Crail Hill  
 From: Chris Osterrieder [osterrieder@delucahoffman.com]  
 Sent: Tuesday, October 10, 2006 12:48 PM  
 To: Randy Alred; Drew Shiers  
 Cc: Howard@delucahoffman.com; Crail Hill  
 Subject: Revised PR-3  
 Follow Up Flag: Follow up  
 Flag Status: Red

PROJECT: CUSTOM HOUSE SQUARE OFFICE BUILDING  
 SHEET TITLE: ELECTRICAL PLAN  
 CLIENT: OLYMPIA EQUITY INVESTORS, IVB

DRAWN: LECJ DATE: NOV. 2005  
 DESIGNED: CJO SCALE: 1"=10'  
 CHECKED: CJO JOB NO. 2581  
 FILE NAME: 2581-SP  
 SHEET: C-4A

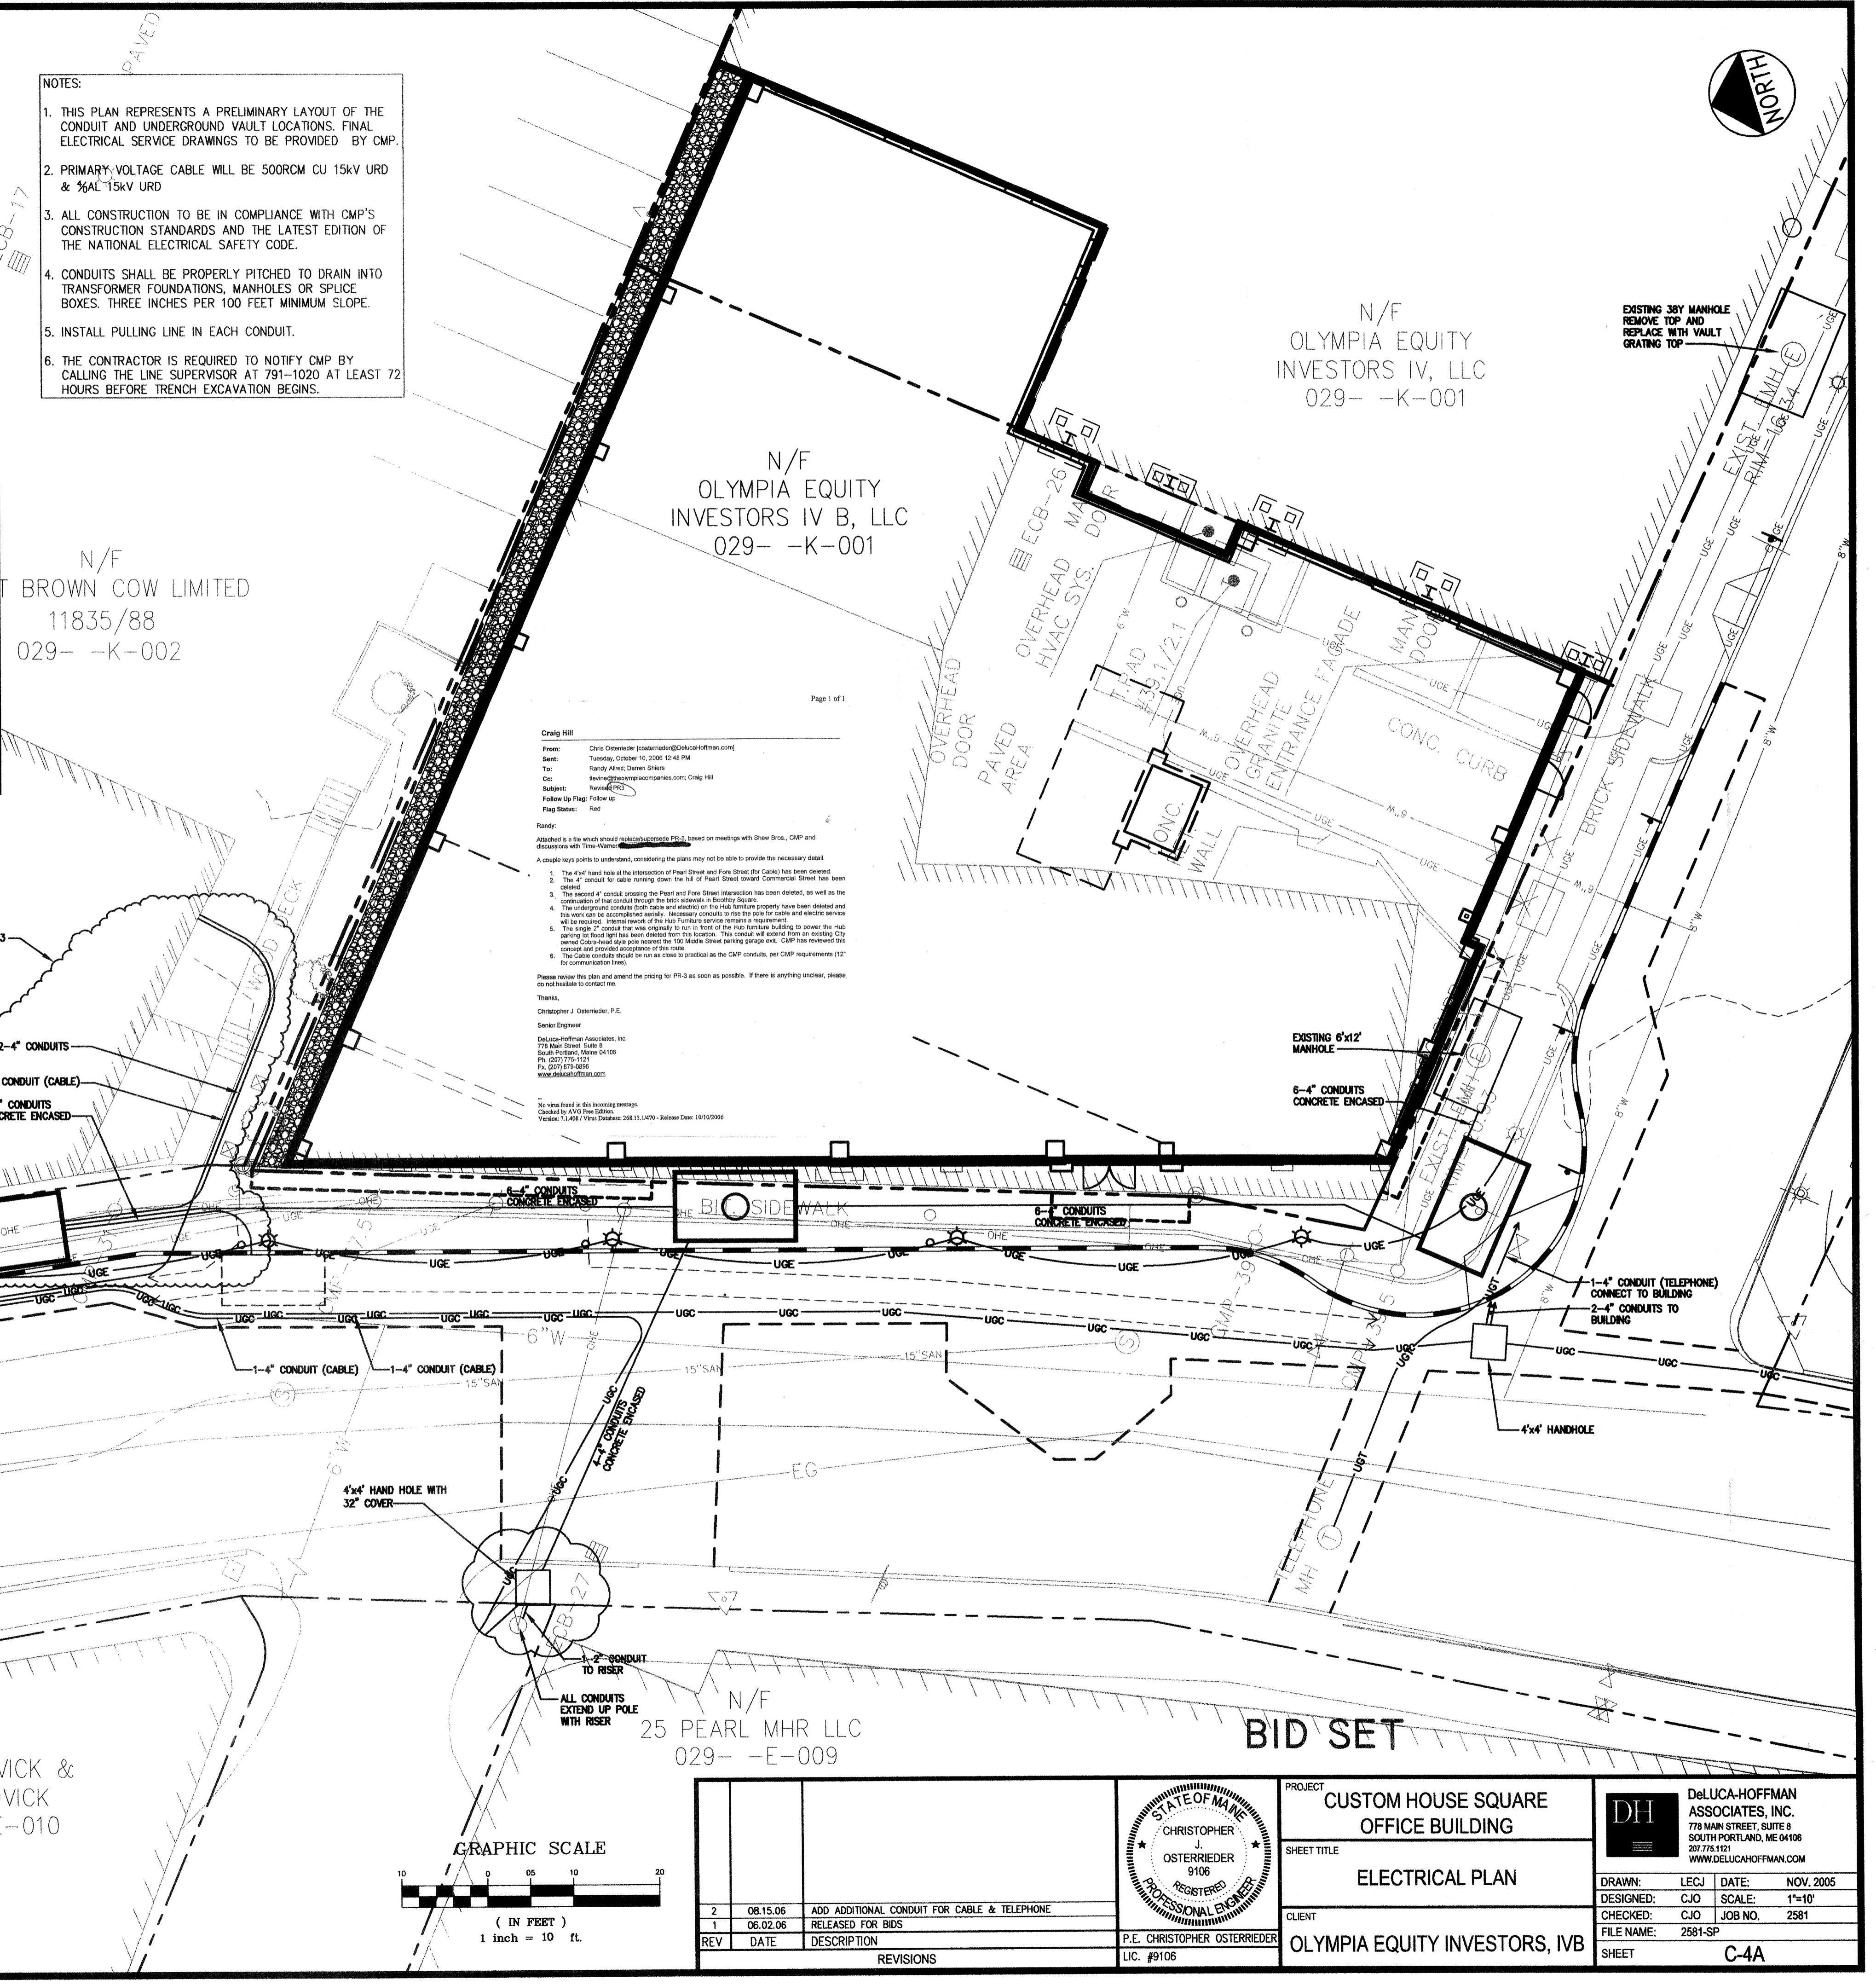
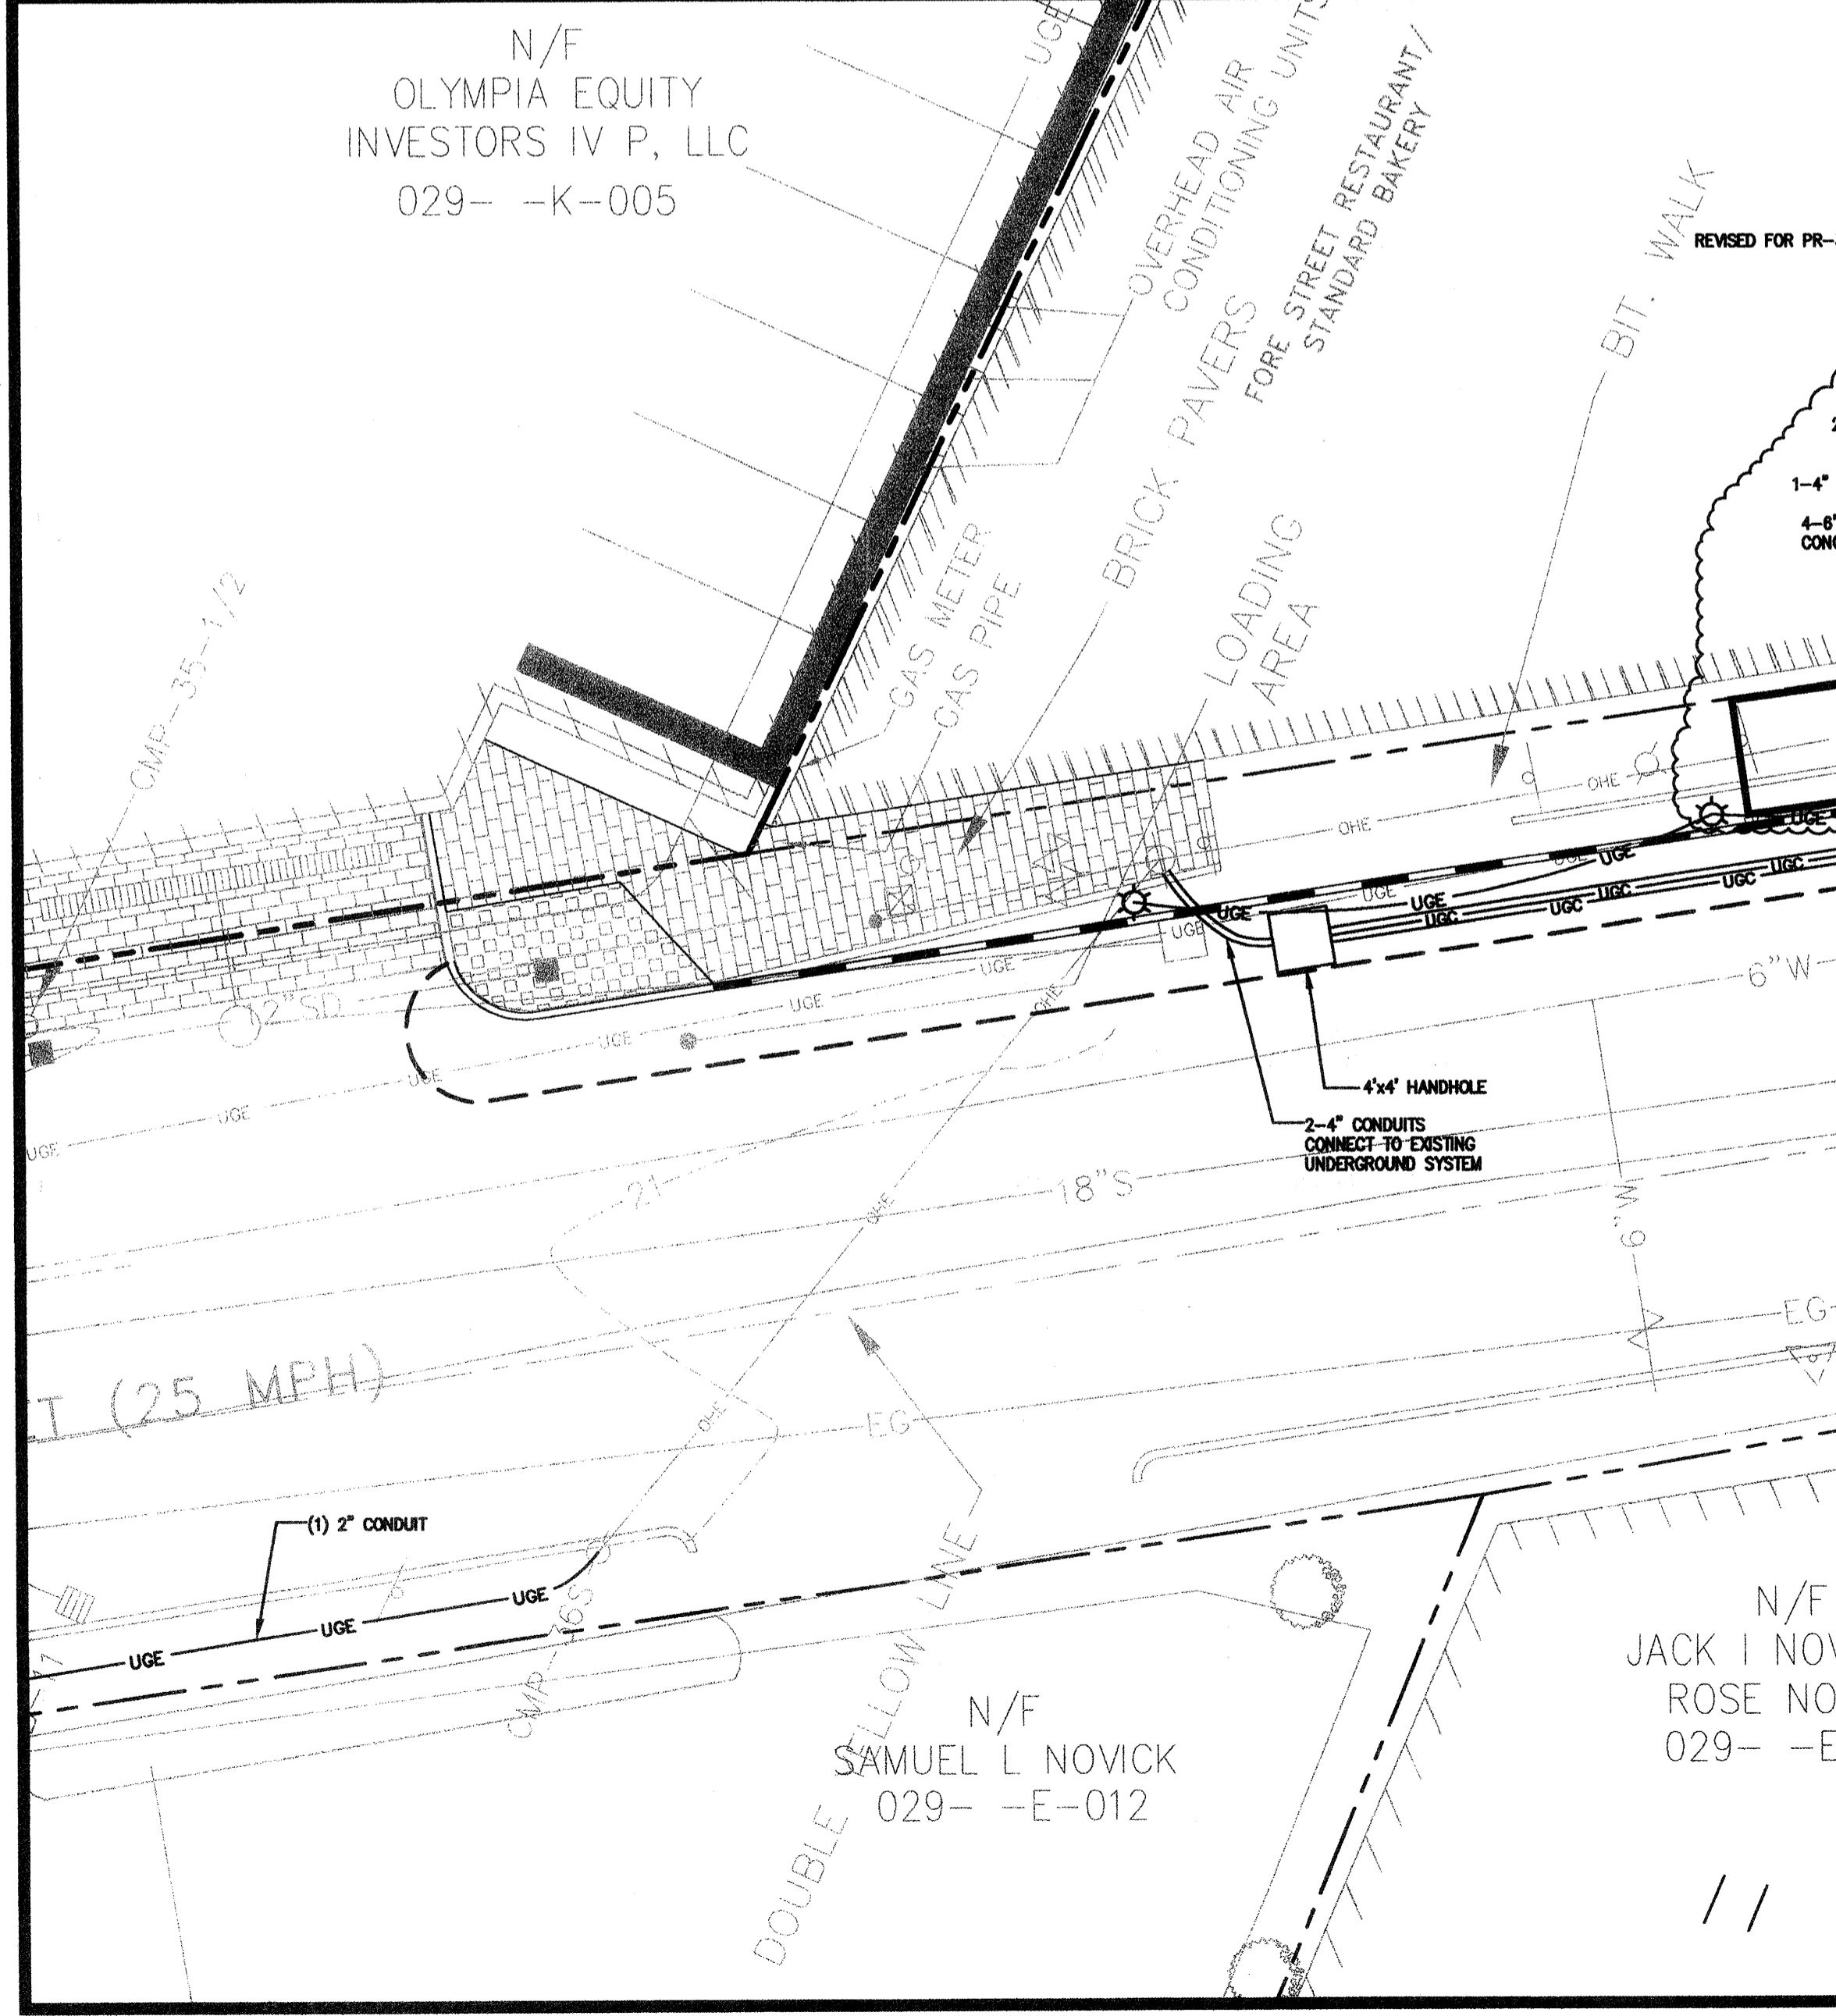
Randy:  
 Attached is a file which should provide you with PR-3, based on meetings with Drew Shiers, CMP and discussions with Drew Shiers. I have revised the plan to provide the necessary detail.  
 A couple key points to understand, considering the plan may not be able to provide the necessary detail:

1. The 4" hand hole at the intersection of Pearl Street and Fore Street (by Casey) has been opened.  
 2. The 4" conduit for cable running down the side of Pearl Street below Commercial Street has been opened.

3. The second 4" conduit crossing the Pearl and Fore Street intersection has been detailed, as well as the location of the conduit through the main entrance in Building 200.

4. The underground conduit (cable and electric) on the main entrance property has been detailed and the work can be completed as needed. Necessary conduits to the site for cable and electric service will be required. Approval of the Map Furniture service remains a requirement.

5. The 4" x 6" conduit that was proposed as a result of the site furniture building to power the Map Furniture is still to be installed from the building. The conduit will be installed from the building to the 100 Middle Street parking garage site. CMP has reviewed the concept and provided a response of the site.

6. The Cable conduits should be run as close to practical as the CMP conduits, per CMP requirements (12" for communication lines).
